KEY WEST CHAPTER 288 MILITARY BASE REUSE PLAN OBJECTIONS,  
RECOMMENDATIONS AND COMMENTS NAS KEY WEST FL  
7/20/1999  
BERMELLO, AJAMIL AND PARTNERS

# KEY WEST CHAPTER 288 MILITARY BASE REUSE PLAN

## Objections, Recommendations and Comments

July 20, 1999

**Figure III.B.8**  
**Proposed Land Use Classification**  
**TRUMAN WATERFRONT PARCEL**  
**KEY WEST MILITARY BASE REUSE PLAN**

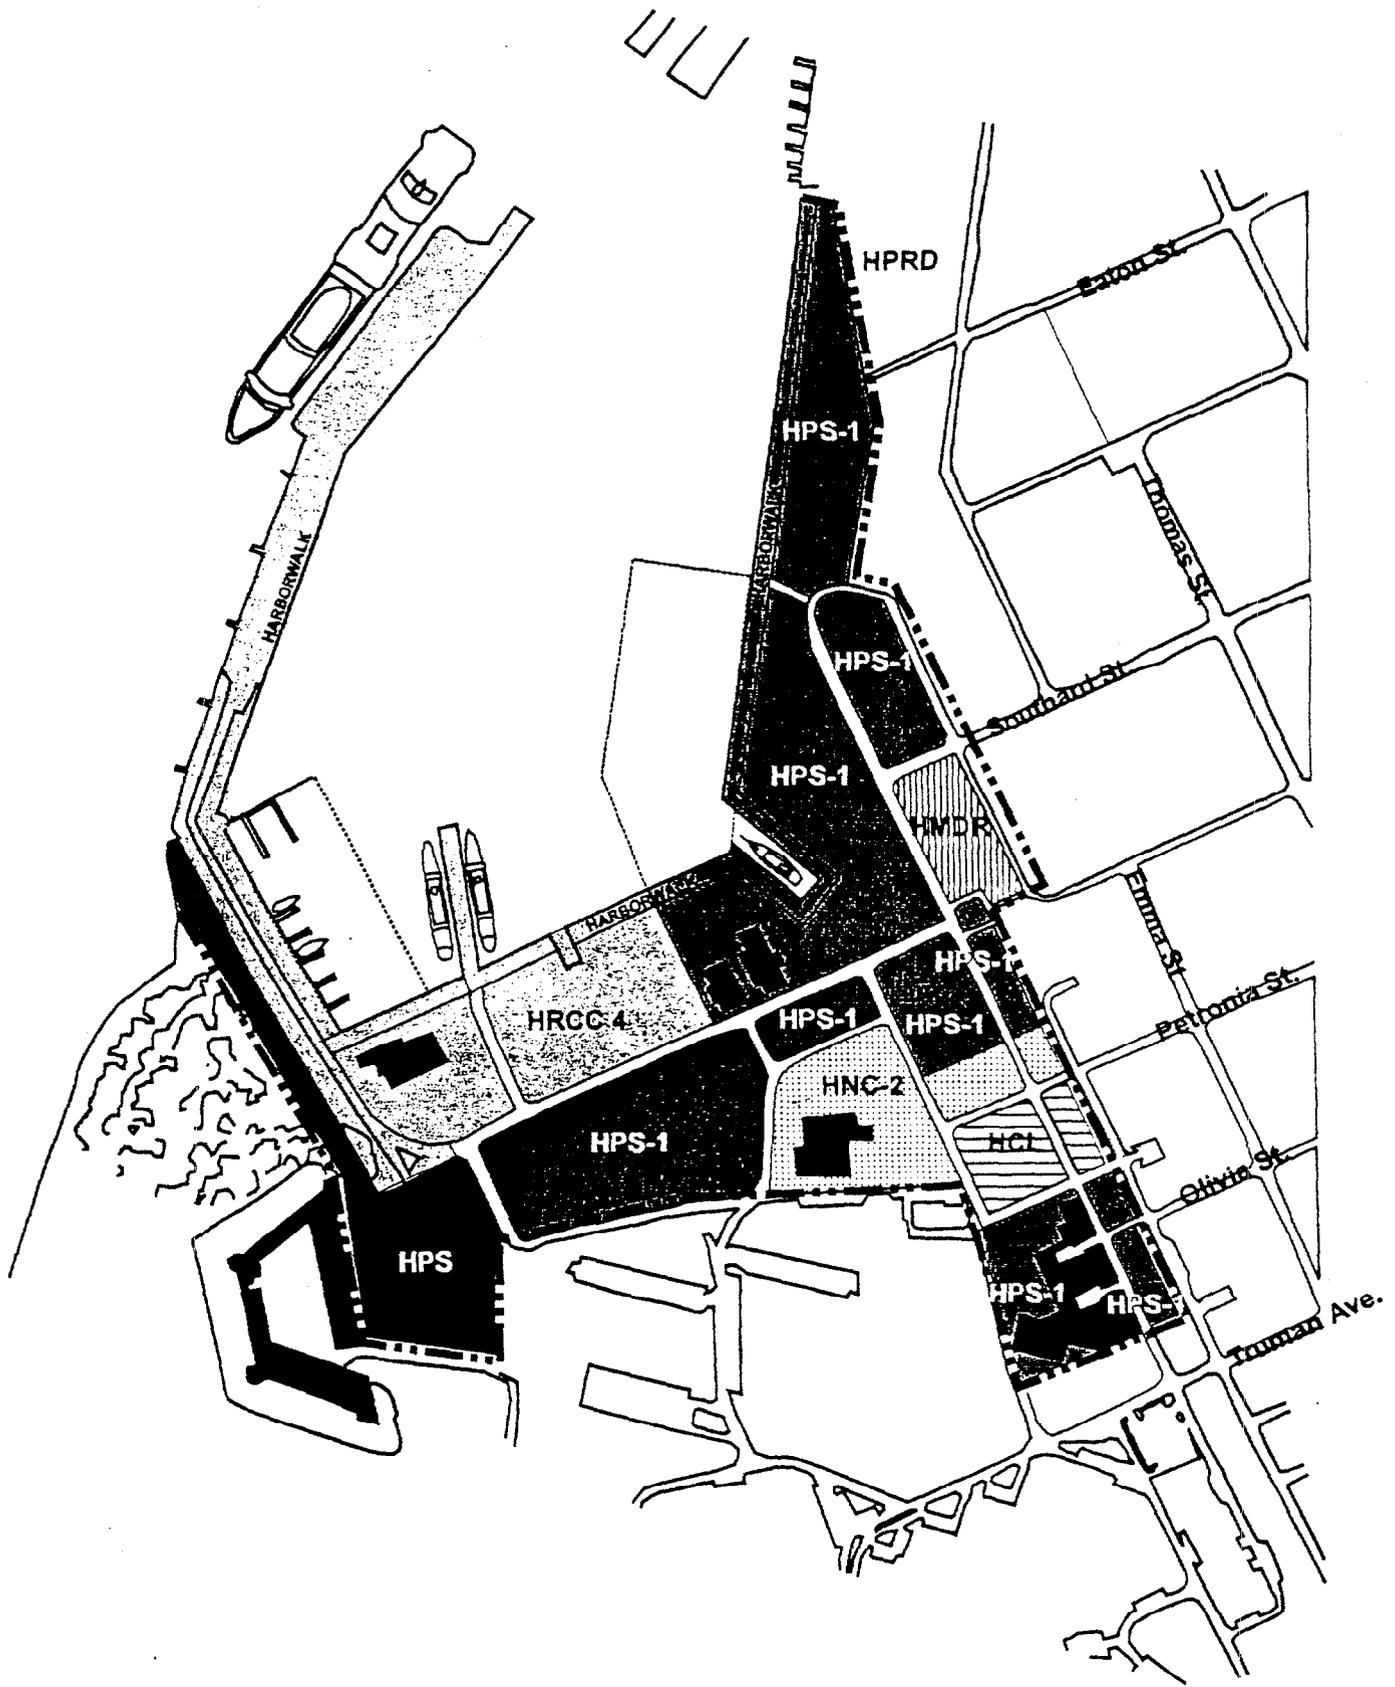
It is not clear that the plan accurately identifies the land that the state hopes to acquire from the federal government and add to Fort Taylor. The plan needs to avoid conflict with the land use configuration we envision for anticipated additions to the park. Attached is a copy of the June 6, 1998 survey which has been submitted to the National Park Service (NPS) as part of our application to procure additional property for the park. This land, along with the existing park, needs to be under the zoning category. Figure III.B.8 of the City Commission Meeting Handouts reflects a portion of this land as public services and a portion as neighborhood commercial. All of the property should be zoned public services.

Figure III.B.8 is meant to provide a general location of proposed land use designations. Specific land use locations will be defined once a survey and legal description of the parcel is completed.
